TITLE: **PRELIMINARY PLAT NO. 01019, EDENTON NORTH 6TH ADDITION**, requested by Engineering Design Consultants and J. Michael Rierden, on behalf of Lincoln Federal Bancorp, Inc., to create approximately 184 single family and two-family lots, with associated waiver requests, on property generally located at South 75th Street and Glynoaks Drive.

RE: Preliminary Plat No. 01019 Edenton North, Sixth Addition

P.A.S.: PP #01019
Edenton North 6th Addition

**SHEET
2 OF 11**

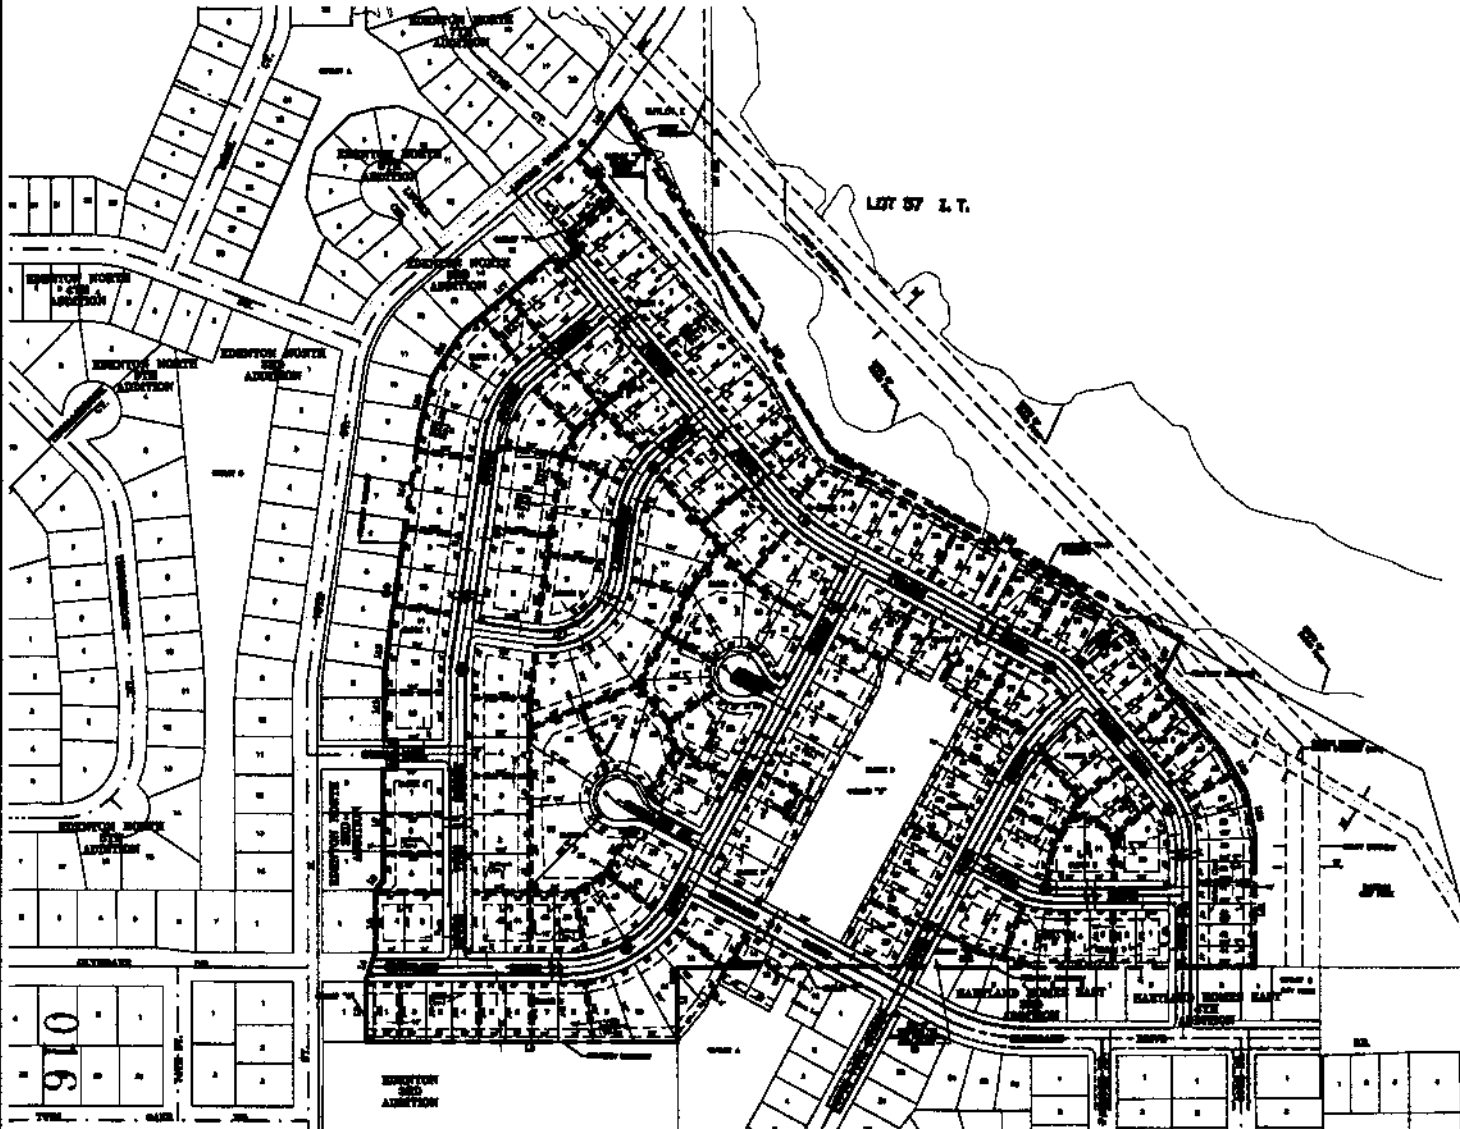
1. After the subdivider completes the following instructions and submits the documents and plans to the Planning Department office, the preliminary plat will be scheduled on the City Council's agenda: (NOTE: These documents and plans are required by ordinance or design standards.)
 - 1.1 Revise the preliminary plat to show:
 - 1.1.7 Revise the grading and drainage plan to the satisfaction of Public Works & Utilities and Parks & Recreation.
 - 1.1.8 Provide two street trees where lots have 100 feet or more of frontage.
 - 1.1.9 Sign the surveyor's certificate.
 - 1.1.10 Remove setback lines. They are not required and obfuscate the utility easements.

- 1.1.11 Add existing residential streets to the vicinity map.
- 1.1.12 Provide a pedestrian way easement in Block 4.
- 1.1.13 Change all references from “Edenton North - Phase II” to “Edenton North 6th Addition” in accordance with plat naming standards.
- 1.1.14 Relocate the “South” label in “South 77th Street” so that it is north of Glynoaks Drive. This will aid in assigning addresses.
- 1.1.15 Revise Note 22 so that the easement location will be determined at the time of the final plat.
- 1.1.16 Remove the lots and use tables. The data required with a preliminary plat are: number of lots, number of outlots, number of blocks, and purpose of outlots.

1. Water - The water main in Glynoaks Drive needs to be shown as 12" in size. This has not been changed per the previous review. I note it has been revised west to 77th, but not west to the west limits of the plat.

The storm sewer shown in Outlot D does not work with the grades. The location of the pipe does not meet the outlet ditch shown on the adjacent property. If the 36" pipe is built with the required cover, the flow line will be below existing grades. The realignment I anticipate being required may require realignment of Lots 24 and 25, Block 6 and Outlot D.

4. Sidewalks - There is not a pedestrian easement shown between Lots 24 and 25 in Outlot D as stated in the letter. There is an easement shown between Lots 28 and 29. In reviewing the grading plan, it appears that a pedestrian easement does not work in either location without revisions to the grading plan.
